Risks and Impacts from a Tailings Dam Failure at the Proposed Pebble Mine

April 1, 2019

Overview

Draft EIS is Misleading about Failure Probability

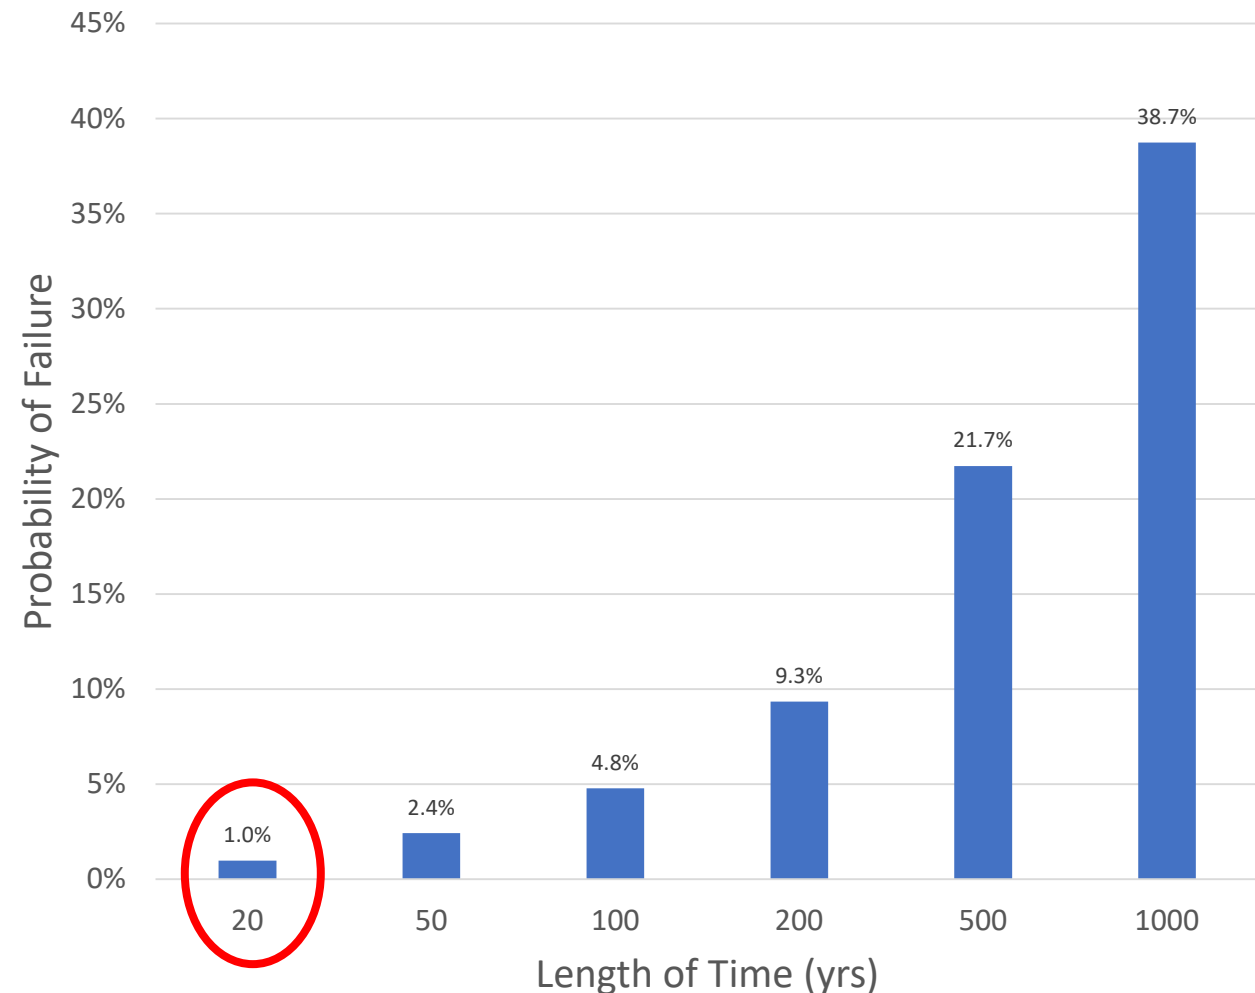
“The probability of a full breach of the bulk or pyritic TSF tailings embankments was assessed to be extremely low”

- DEIS p. 4.27-72

“[a full tailings breach was] ruled out as remote **during the 20-year operational life** due to likelihood of successful detection and intervention”

- FMEA, October 2018

Probability of "1 in 2000" event over time

Breach Volume Released vs Tailings Storage Facility Capacity

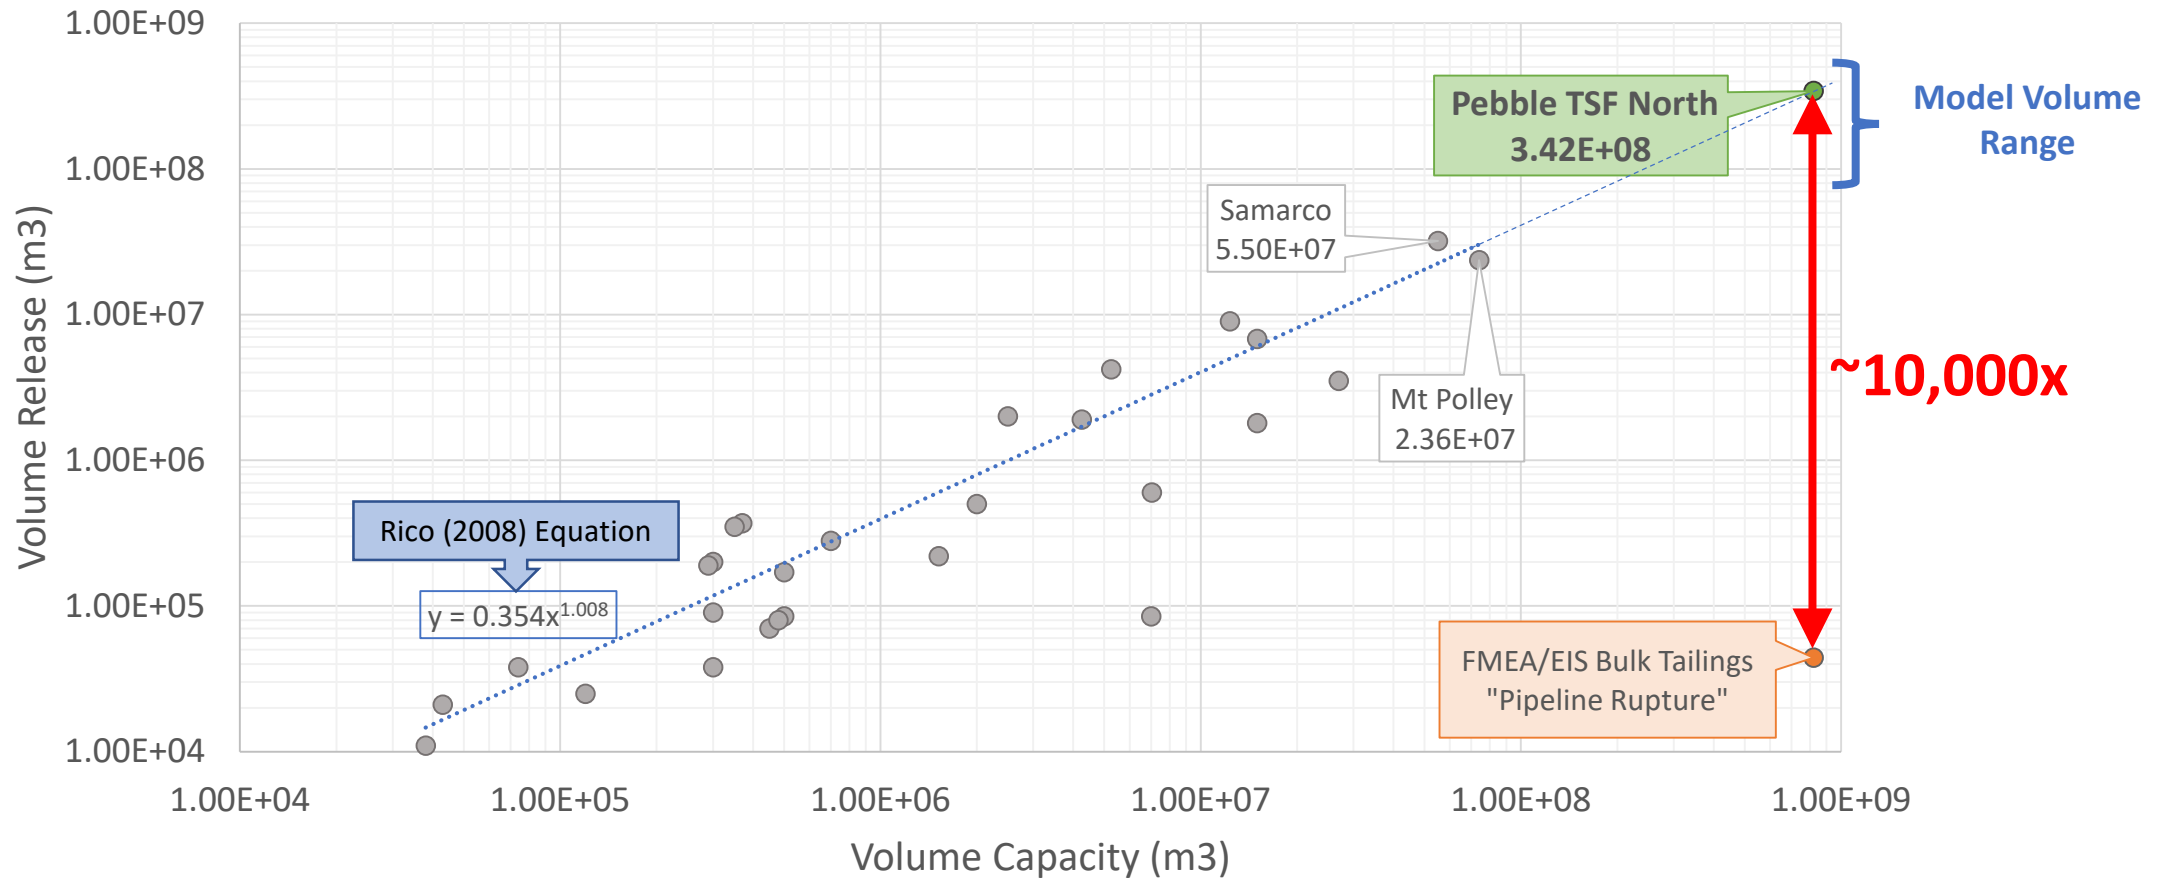
Draft EIS Did NOT consider a TSF failure
